WATERBURY FILING NO. 1

CONSTRUCTION SET

GRADING AND EROSION CONTROL PLAN

OUTLET STRUCTURE MODIFIED TYPE 1 MH

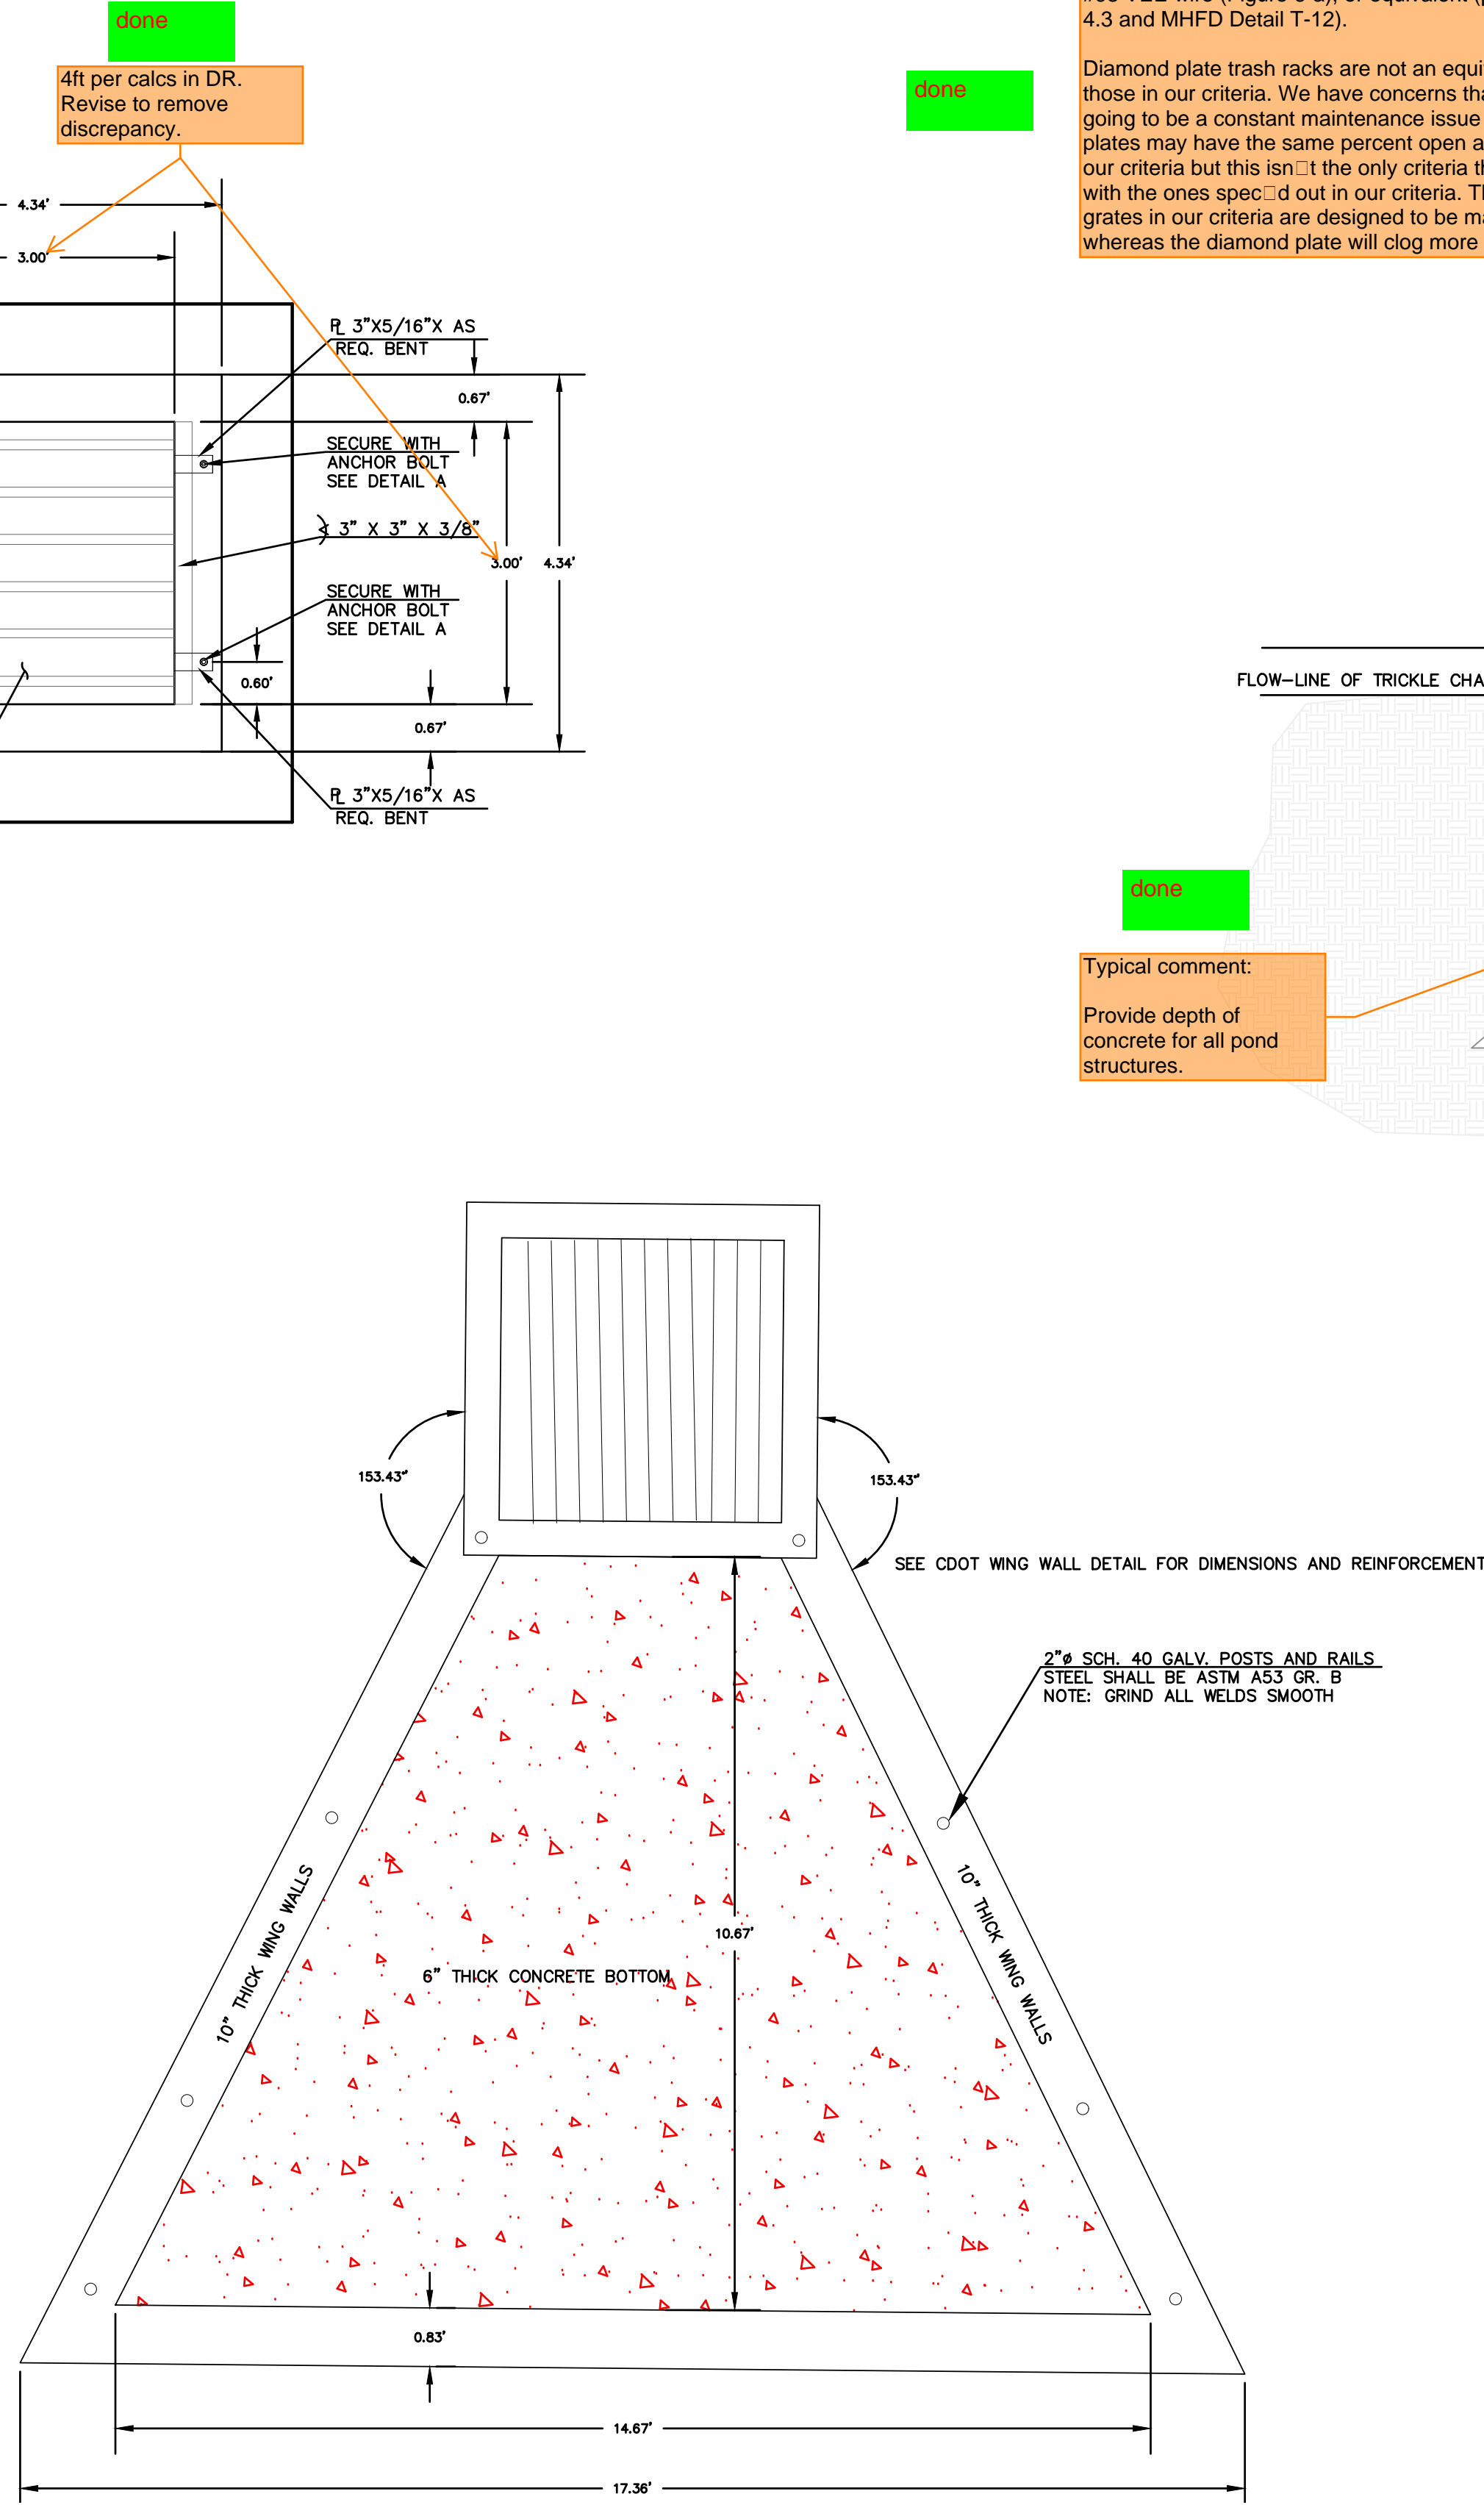
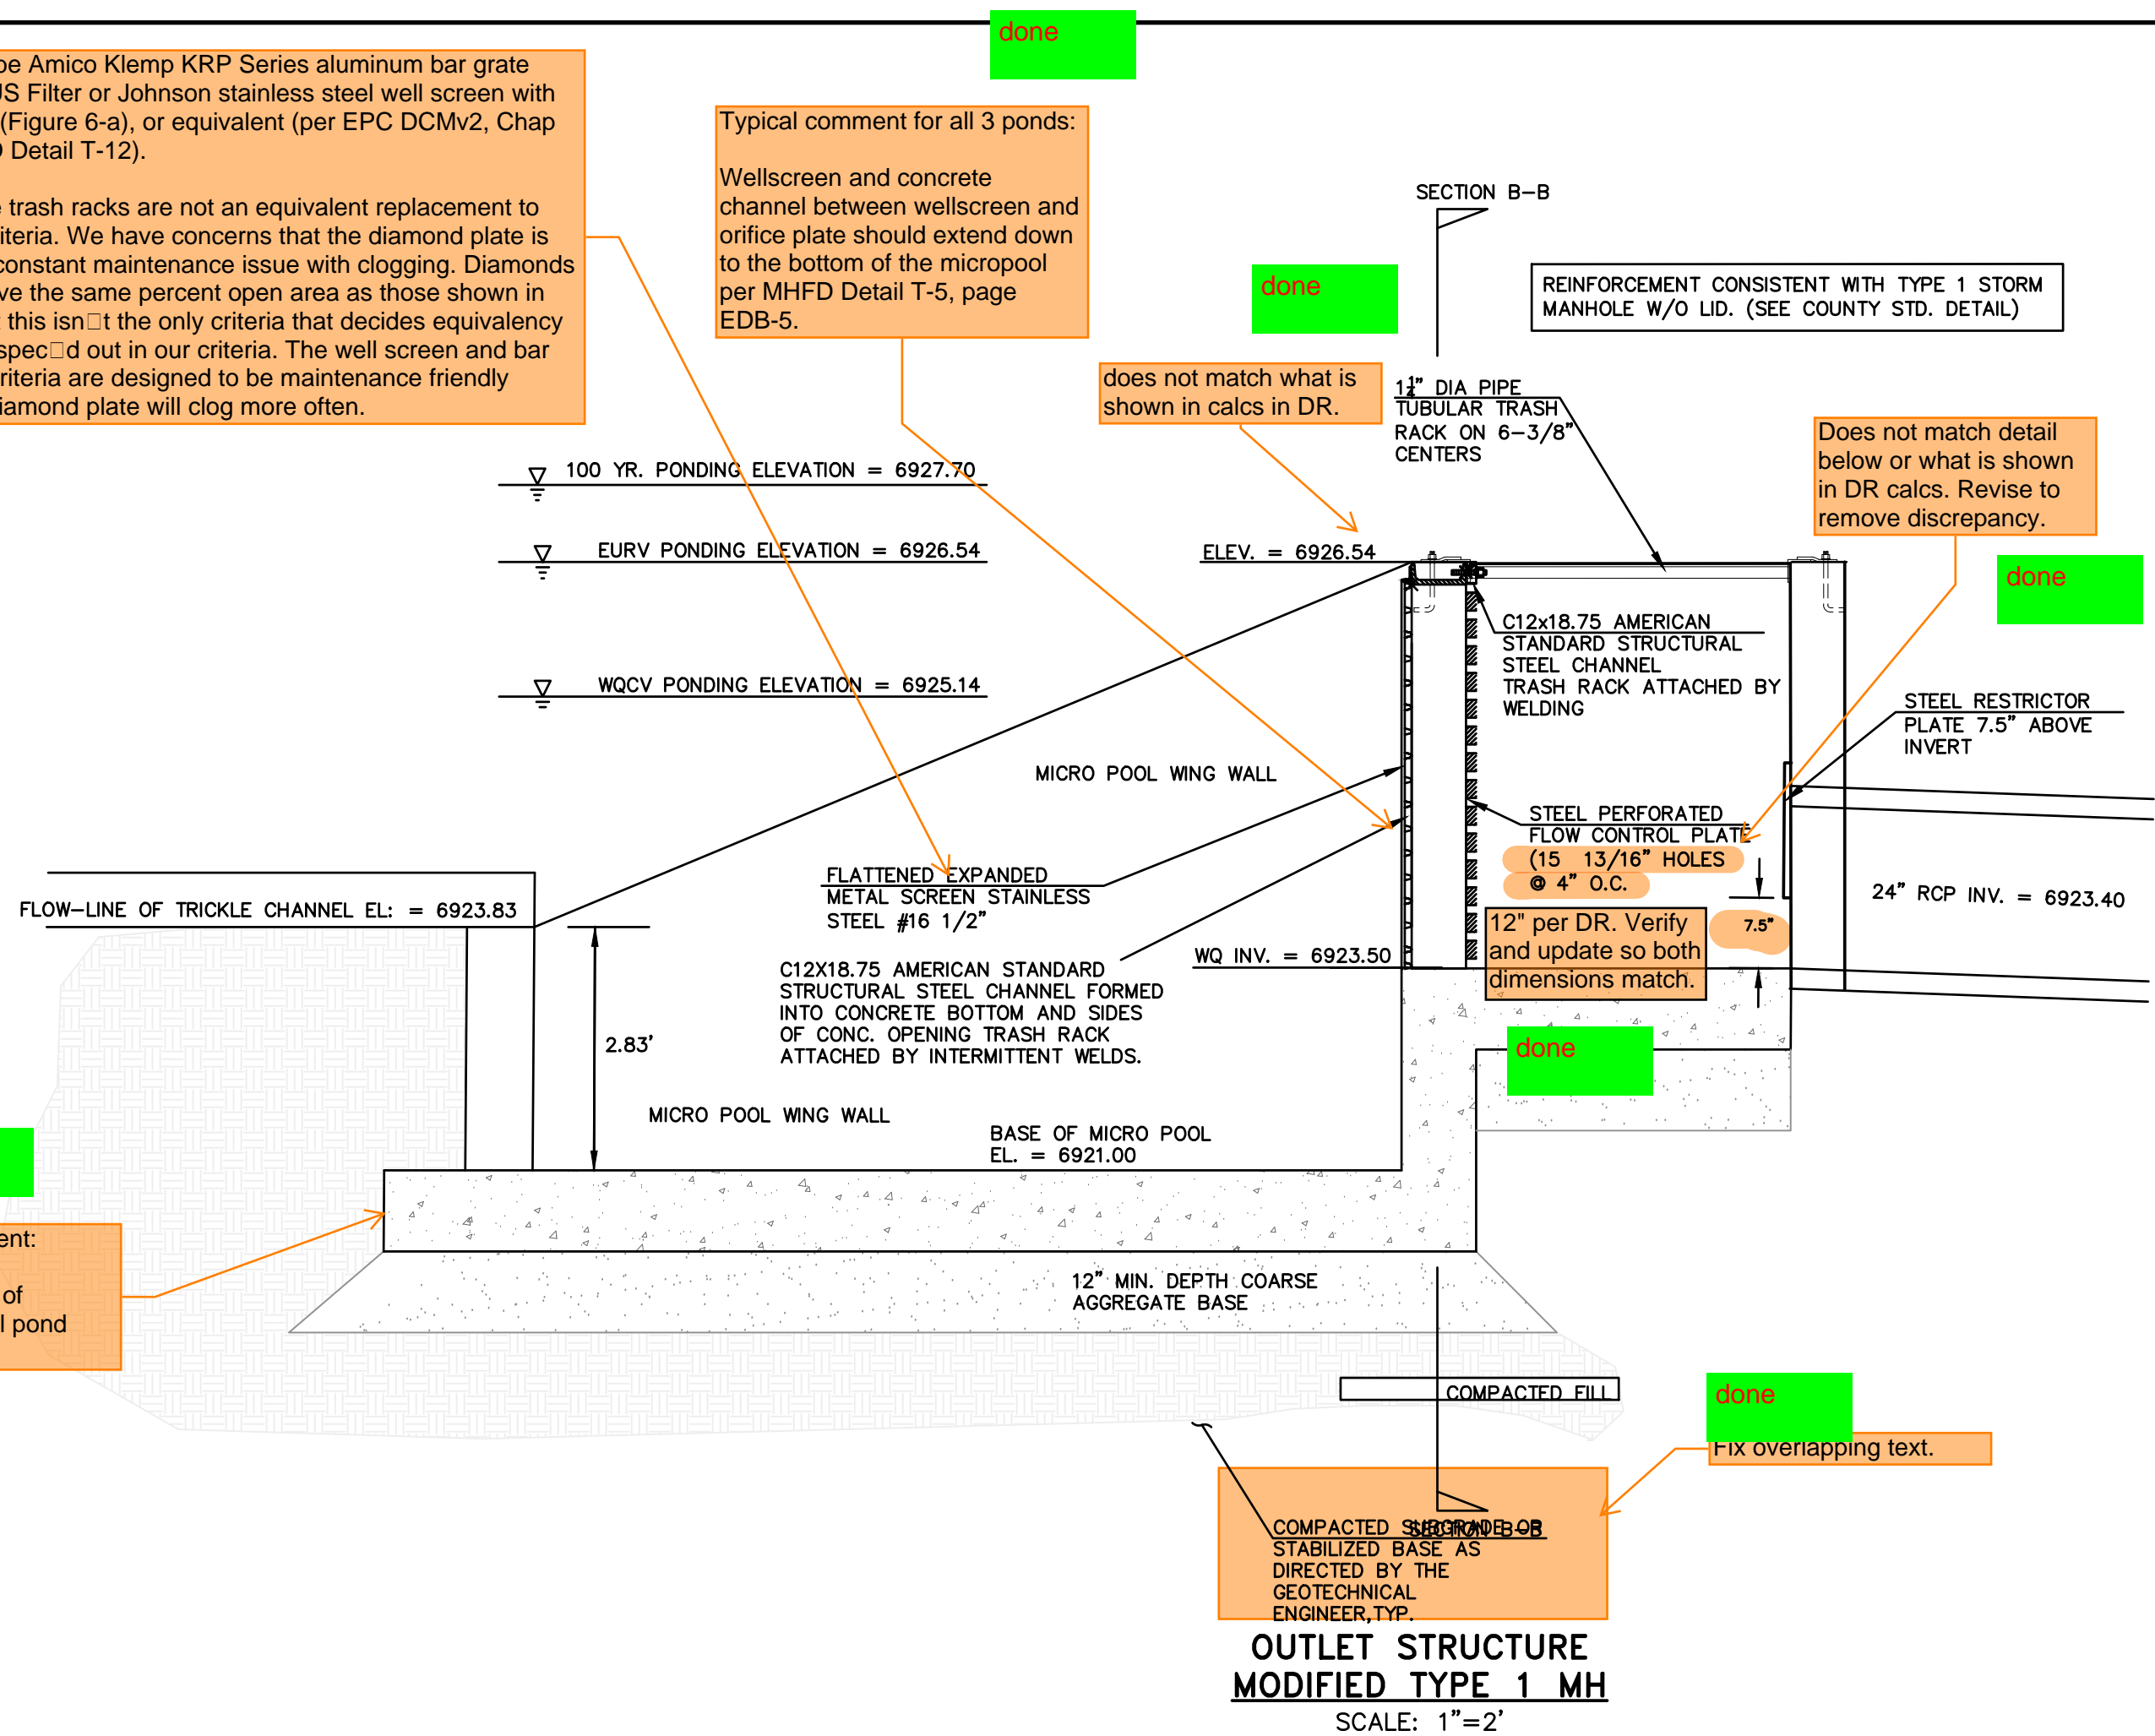
Typical comment for all 3 ponds:
Include callout for pet waste station(s) around the pond, with signage stating that pet waste must be picked up.

Typical comment for all 3 ponds:
Provide maintenance access road detail/cross section, including stone sizing and gradation. Show cross slope at 2%.

Trash rack to be Amico Klemp KRP Series aluminum bar grate (Figure 6-b), US Filter or Johnson stainless steel well screen with #93 VEE wire (Figure 6-a), or equivalent (per EPC DCMv2, Chap 4.3 and MHFD Detail T-12).

Diamond plate trash racks are not an equivalent replacement to those in our criteria. We have concerns that the diamond plate is going to be a constant maintenance issue with clogging. Diamonds plates may have the same percent open area as those shown in our criteria but this isn't the only criteria that decides equivalency with the ones specified in our criteria. The well screen and bar grates in our criteria are designed to be maintenance friendly whereas the diamond plate will clog more often.

Wellscreen and concrete channel between wellscreen and orifice plate should extend down to the bottom of the micropool per MHFD Detail T-5, page EDB-5.

Does not match detail below or what is shown in DR calcs. Revise to remove discrepancy.

Typical comment:
Provide depth of concrete for all pond structures.

Callout each individual orifice, so it is clear.

Typical comment for similar details on all 3 ponds:
Pond bottom should have a minimum slope of 3% to the trickle channel and micropool (USDCM Vol 3, detail T-5). Please adjust to minimize future maintenance needs.

Typical comment for similar details on all 3 ponds:
Consider having control joints every ~10ft.

Per MHFD Detail T-5, a longitudinal slope between 0.4-1% is recommended to encourage settling while reducing the potential for low points.
